# IOWA DEPARTMENT OF NATURAL RESOURCES LAND & WATERS BUREAU WALLACE STATE OFFICE BUILDING

ODESSA WMA
ROAD MAINTENANCE
LOUISA COUNTY, IOWA
PROJECT NUMBER: 21-06-58-03

#### 8/12/2022

This Addendum is issued to modify, explain or correct the original Drawings and Specifications, and is hereby made a part of the Contract Documents. Please attach this Addendum to the Project Manual in your possession. Insert the number and issue date of this Addendum in the blank space provided on the Proposal Form.

C.01

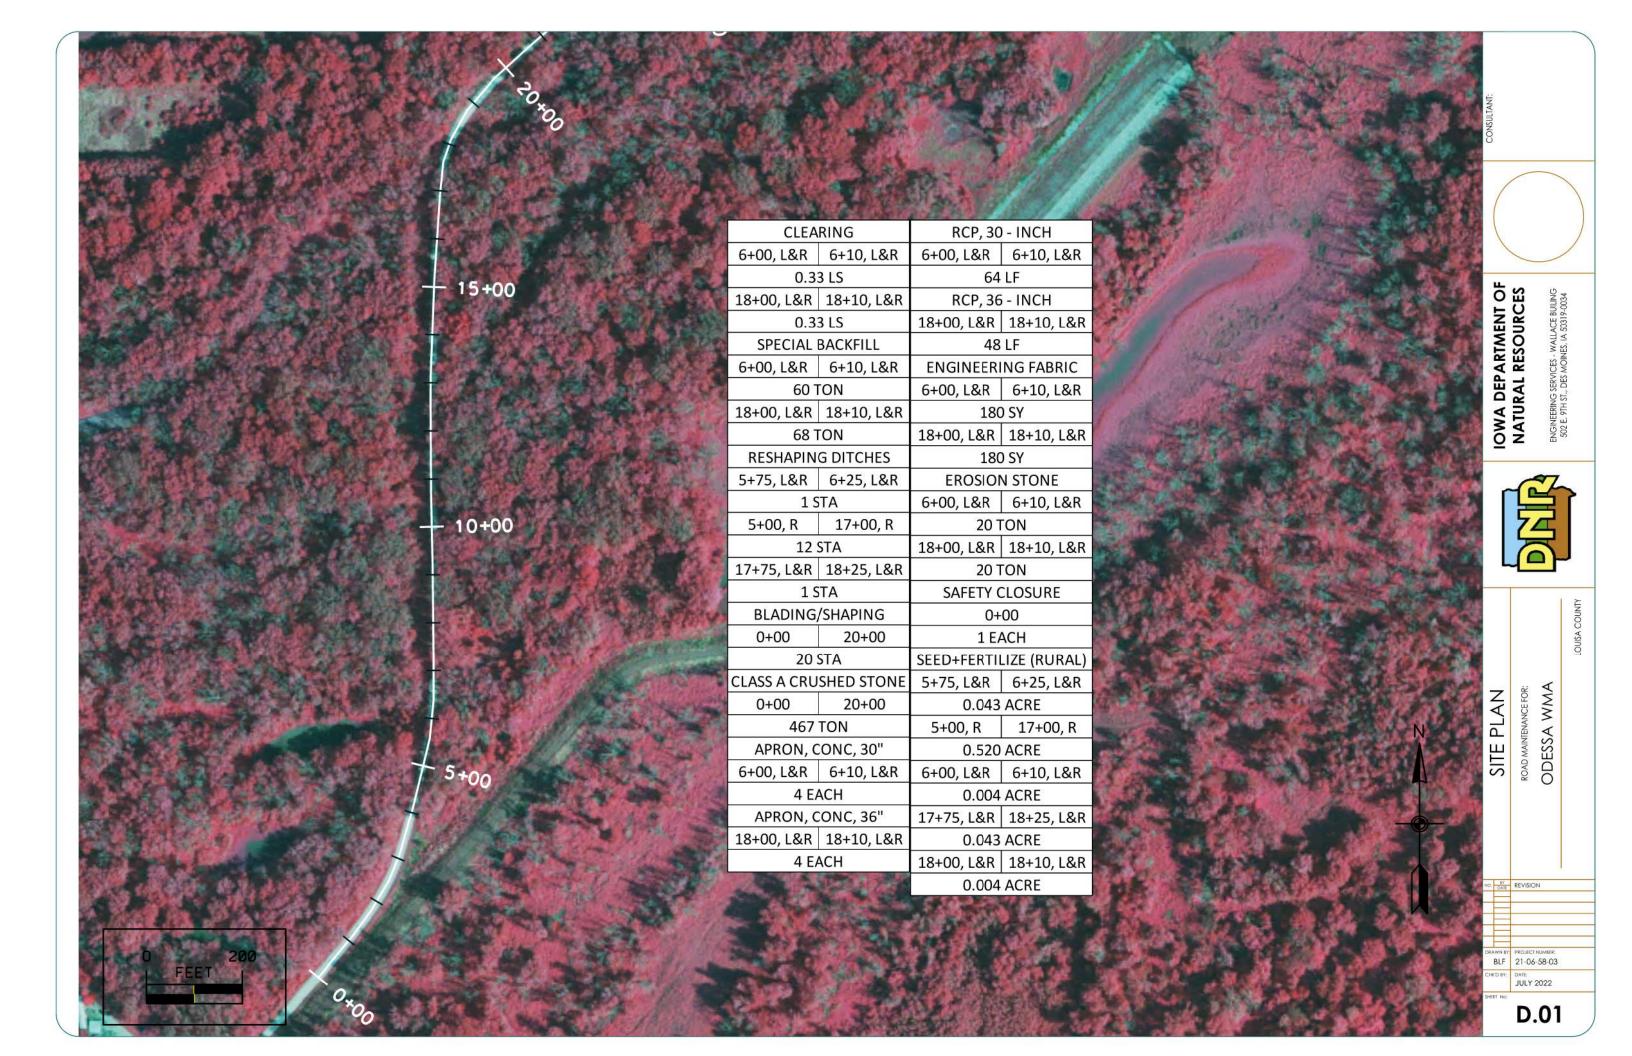
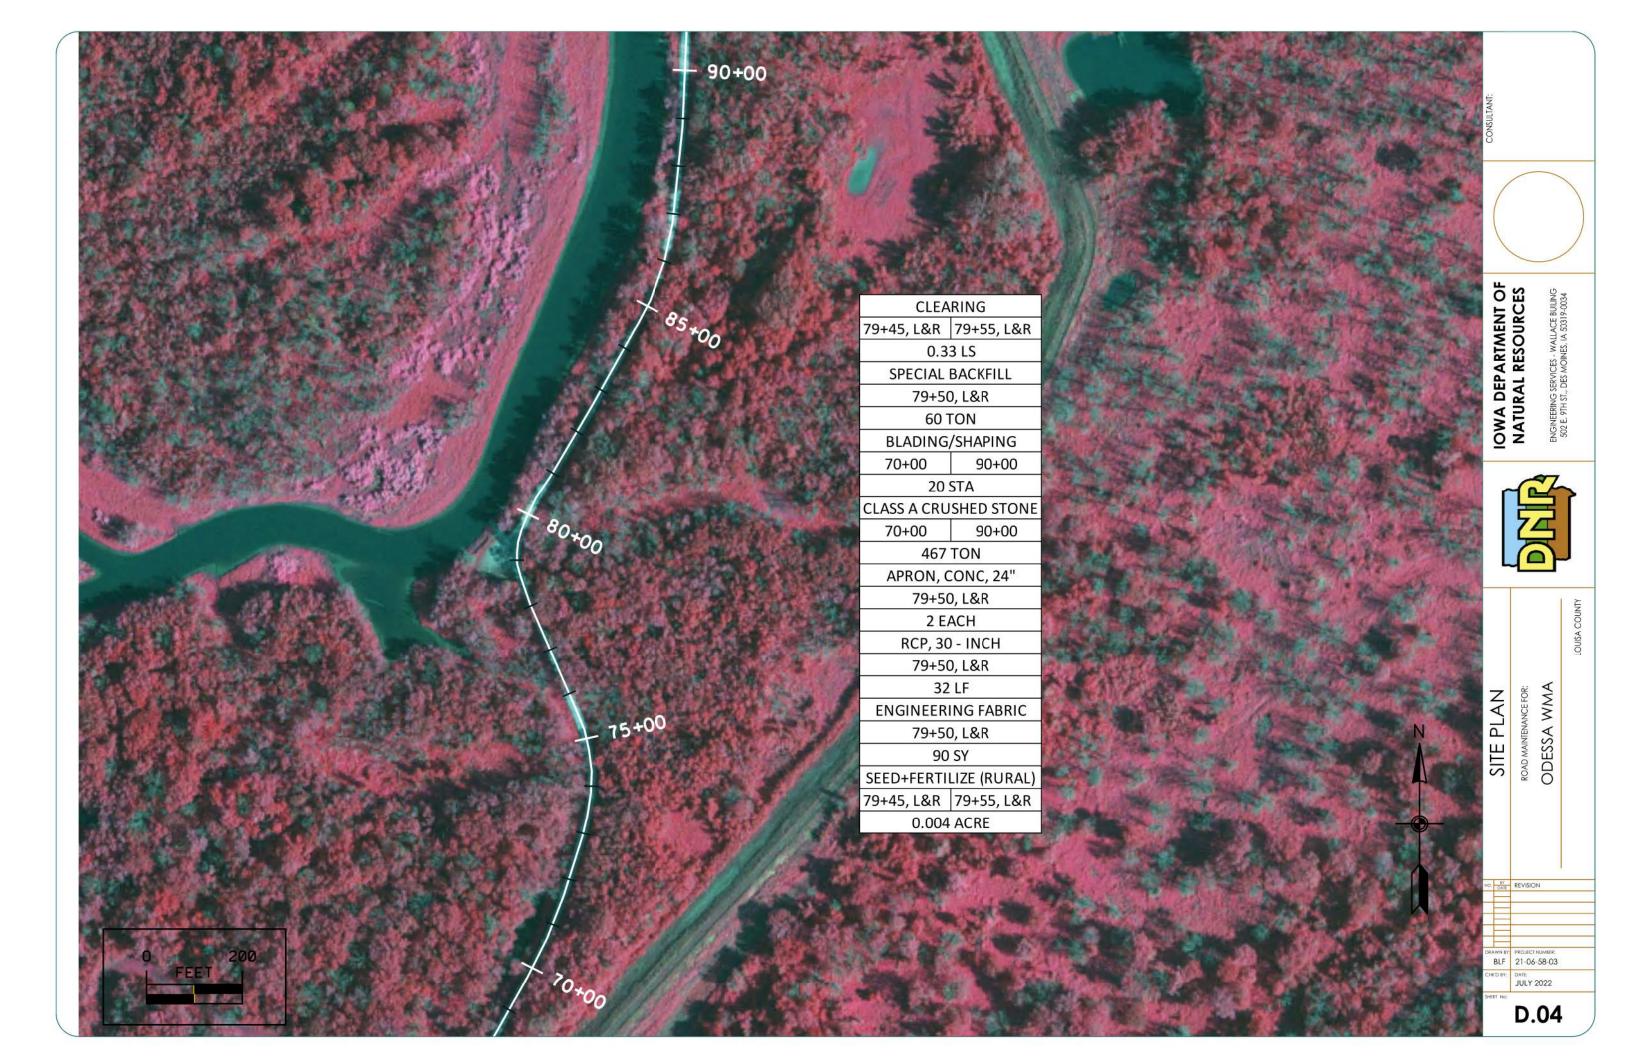
- A. Sheet C.01 ESTIMATED PROJECT QUANTITIES
  - 1. ADD: ITEM No. 18; 2599 SEED+FERTILIZE (RURAL), 1 ACRE.
- B. Sheet C.01 Estimate Reference Information Section
  - 1. ITEM No. 2:
    - a. ADD C. Place 6 inches of special backfill under RCP and halfway up pipe.
    - b. ADD D. Remove any excess spoil from project site.
    - c. ADD E. Iowa DOT gradation No. 30.
    - d. ADD F. DOT approved source.
  - 2. ADD ITEM No. 18
    - a. ADD A. Rural Mix.
    - b. ADD B. DOT approved source.
  - 3. ITEM NO.'s in the ERI section do not match the ITEM NO.'s in the Estimated Project Quantities section. Updated numbering for Sheet C.01 is attached.

ITEM NO.	ITEM	UNIT	TOTAL
1	2101 - CLEARING	LS	1
2	2102 - SPECIAL BACKFILL	TON	128
3	2125 - RESHAPING DITCHES	STA	23
4	2127 - RECONSTRUCTION OF ROADBED - BLADING/SHAPING	STA	95.4
5	2312 - GRANULAR SURFACING ON ROAD, CLASS A CRUSHED STONE	TON	2225
6	2416 - APRON, CONC, 24"	EACH	2
7	2416 - APRON, CONC, 30"	EACH	4
8	2416 - APRON, CONC, 36"	EACH	4
9	2416 - CULV, CONC RDWY PIPE, 24"	LF	32
10	2416 - CULV, CONC RDWY PIPE, 30"	LF	64
11	2416 - CULV, CONC RDWY PIPE, 36"	LF	48
12	2507 - ENGINEERING FABRIC	SY	450
13	2507 - REVETMENT, CLASS E	TON	15
14	2507 - EROSION STONE	TON	100
15	2518 - SAFETY CLOSURE	EACH	1
16	2528 - TRAFFIC CONTROL	LS	1
17	2533 - MOBILIZATION	LS	1
18	2599 - SEED+FERTILIZE (RURAL)	ACRE	1

B. Plug each end of RCP with soil to prevent piping.
	C. Place 6-inches of special backfill under RCP and halfway up pipe.
	D. Remove any excess spoil from project site.
